Access Compliance Report

Public Rights-of-Way

Intersection ID: 29381	Main Street: GLENDYNE_DR	Cross Street: PLEASANT_DALE_DR	Location: W
ADA ID: 807BA37BC61A	Ramp Type: PerpDiag	Initial Pass/Fail: Fail	Overall Compliance: No
Severity Score: 22.5			
Codes/Mitigation Info/Possible Solution		Field Measurements/Component Compliance

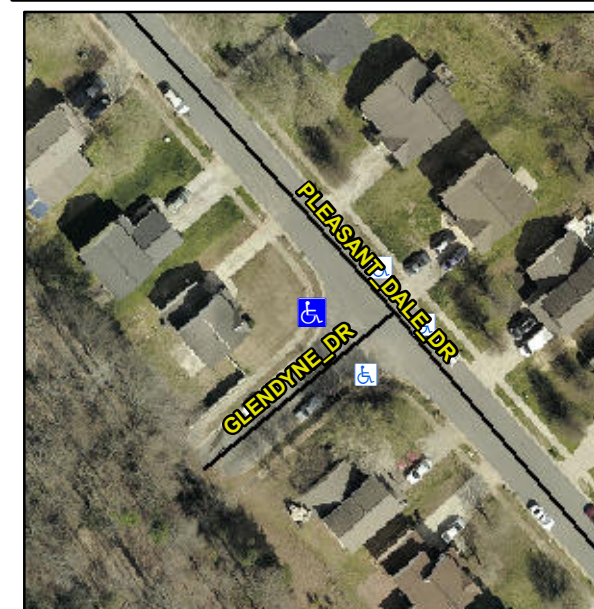
Not Found, R304.5.1, R304.2.2, R304.5.3

Compliance	Description	Data	Compliance	Description	Data
N/A	Ramp Length (in)	47.0	No	Ramp Slope (%)	8.4
No	Ramp Width (in)	42.0	No	Ramp XSlope (%)	2.9
N/A	Flare Type LT	N/A	N/A	Flare Type RT	N/A
N/A	Flare Slope LT (%)	N/A	N/A	Flare Slope RT (%)	N/A
N/A	Flare Traversable LT?	N/A	N/A	Flare Traversable RT?	N/A
N/A	Landing Length (in)	N/A	N/A	DWS Provided?	N/A
N/A	Landing Width (in)	N/A	N/A	DWS Contrast?	N/A
N/A	Landing Slope (%)	N/A	N/A	DWS Length (in)	N/A
N/A	Landing X Slope (%)	N/A	N/A	DWS Full Width?	N/A
N/A	Landing Curb? (Y/N)	N/A	N/A	DWS Offset (in)	N/A
N/A	Shared Landing?	N/A			
N/A	Gutter Ponding?	N/A	N/A	Gutter Slope (%)	N/A
N/A	Gutter Lip Ht (in)	N/A	N/A	Gutter X Slope (%)	N/A
N/A	Painted X Walk1?	No	N/A	Painted X Walk2?	No
	X Walk 1 Direction	To SE		X Walk 2 Direction	To NE
N/A	X Walk 1 Width (in)	N/A	N/A	X Walk 2 Width (in)	N/A
	X Walk 1 Slope (%)	3.1		X Walk 2 Slope (%)	2.0
	X Walk 1 X Slope (%)	0.7		X Walk 2 X Slope (%)	1.9

Remove & Replace Curb Ramp With Two New Directional Ramps or Equivalent.
